Bid# 19132 Lake County Jail-Waukegan: Babcox Mechanical Infrastructure Projects - AHU Replacement - Smoke Evacuation - Chiller Demo RFP: ADDENDUM-2: RFI's 23-32 and two related drawings; dated 07/31/2019

Detention ceiling 1985 design detail (re: RFI-25):

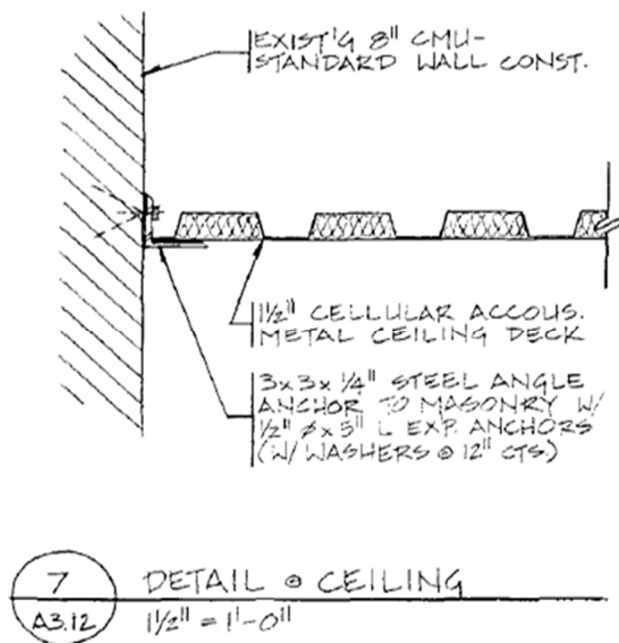
Q: Please provide a specification on the existing ceiling system for removal purposes.

A: The existing ceiling is a suspended on angle iron supports and steel tack-welded detention grade ceiling system from the 1985 construction (see ceiling design detail below).

BABCOX BASEMENT
LEVEL POWER DEMO
PLAN - AREA A

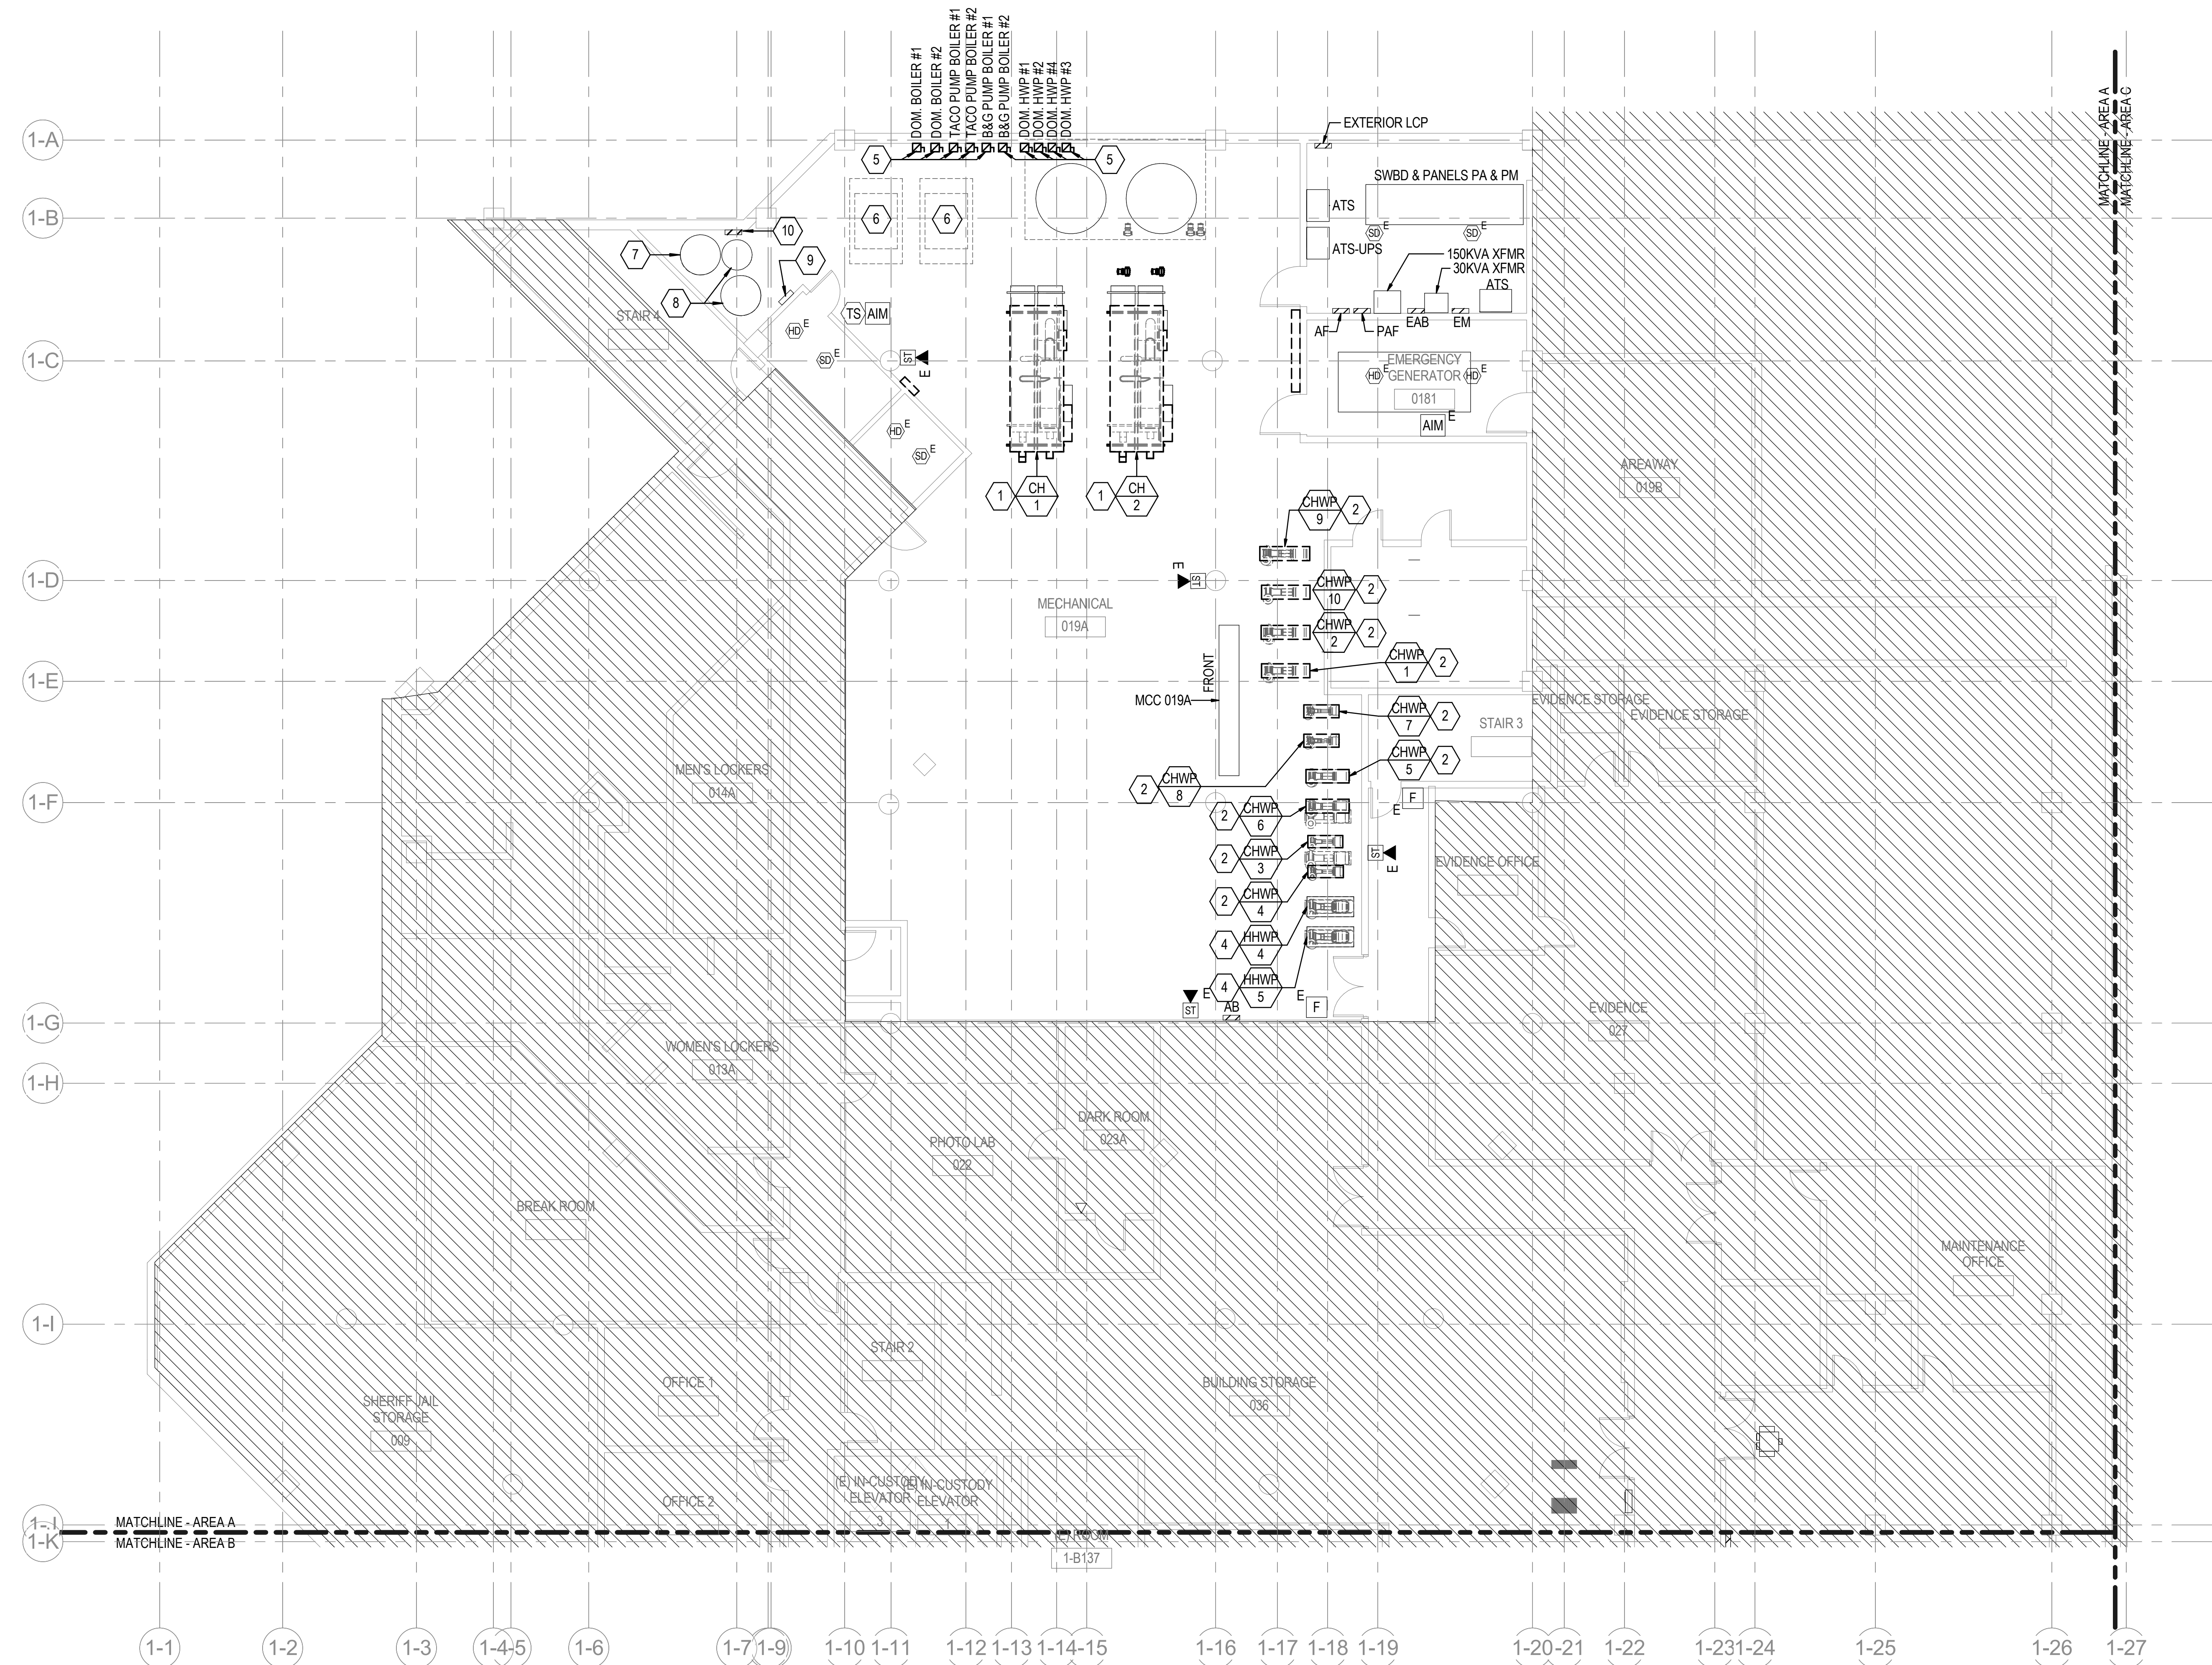
Q: No drawings for the electrical demo or power plans for Area A in the basement have been provided. Will those drawings be issued in an addendum?

A: Yes, two new drawings have been issued in response to this RFI. Refer to the drawing list below and attached to Addendum-2, dated 7/31/2019.
